UNITED STATES PATENT AND TRADEMARK OFFICE

APPLICATION NO.	FILING DATE	FIRST NAMED INVENTOR	ATTORNEY DOCKET NO.	CONFIRMATION NO.
10/733,260	12/12/2003	Toru Takayama	0756-7226	8689

Office Action Summary	Application No. 10/733,260	Applicant(s) TAKAYAMA ET AL.	
	Examiner Andrés López-Esquerro	Art Unit 2818

DETAILED ACTION

Figure 4B

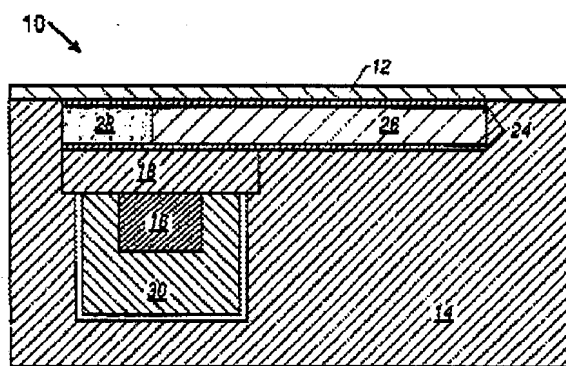
6. As for claims 1, 4, 7, and 10, Freeman discloses (Col. 4 line 15 – Col. 5 line 9) and shows in Fig. 4B a flexible card with a display comprising:

- a. a display device (22);
- b. a thin film integrated circuit (16);
- c. a semiconductor element used for the thin film integrated circuit and the display device is formed by using a polycrystalline semiconductor film (14)
- d. display device is a passive matrix type or an active matrix type (display device is an LCD controlled by the IC, therefore is an active matrix one) (Col 4 lines 38 – 52);
- e. the thin film integrated circuit is laminated (12);

f. the display device and the thin film integrated circuit are equipped for the same printed wiring board (14).

7. A recitation of "driving of the display device is controlled by the thin film integrated circuit" of the claimed invention does not result in a structural difference between the claimed invention and the prior art, thus claimed invention is only an art recognized suitability for an intended purpose, MPEP 2144.07.

8. Freeman fails to disclose the thickness of the IC card to be from .005 mm to 1 mm.
